PLAN AND PROFILE OF PROPOSED
PATH 400 TRAIL
PEACHTREE PARK
MULTI-USE PATH
FULTON COUNTY

APPROVED WITH NOTES

LIVABLE BUCKHEAD INC. & CITY OF ATLANTA
CONSTRUCTION PLAN
PATH 400
PEACHTREE PARK

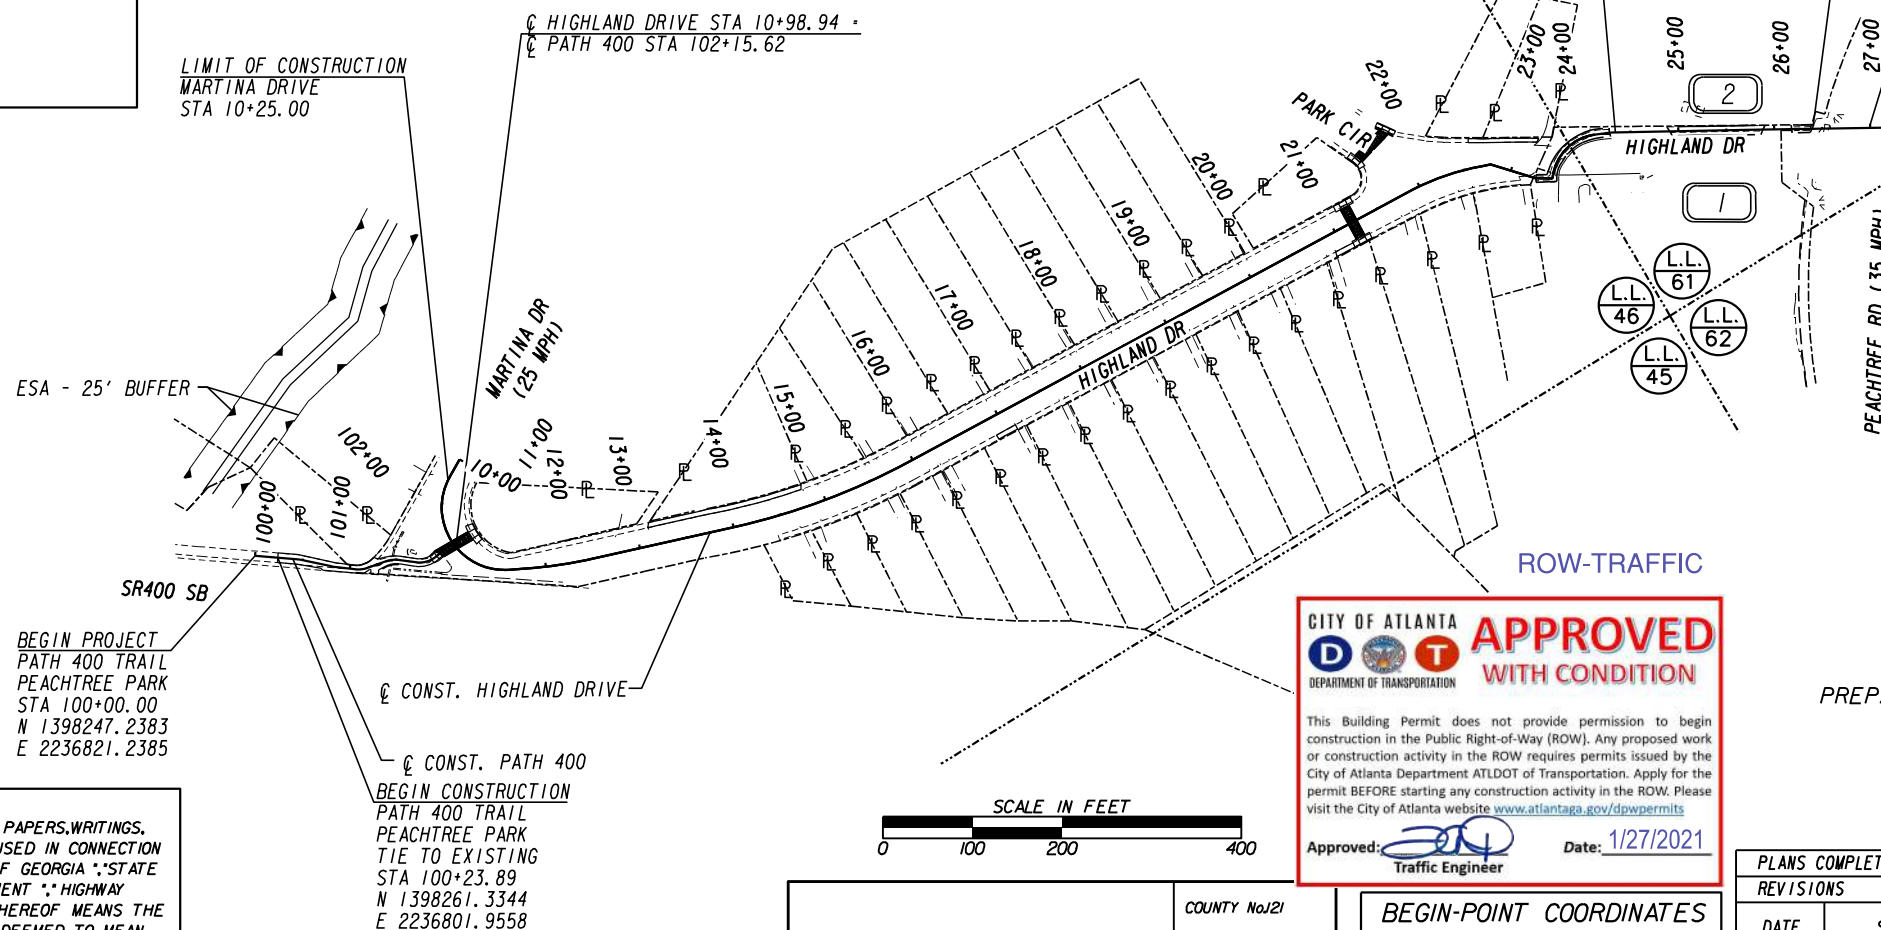
Provide and install the driveway apron according to COA standard include on the detail sheets.

Replace both dismount signs with W1-3L sign (same size)

Replace both 'CONGESTED AREA' sign text with 'SLOW'
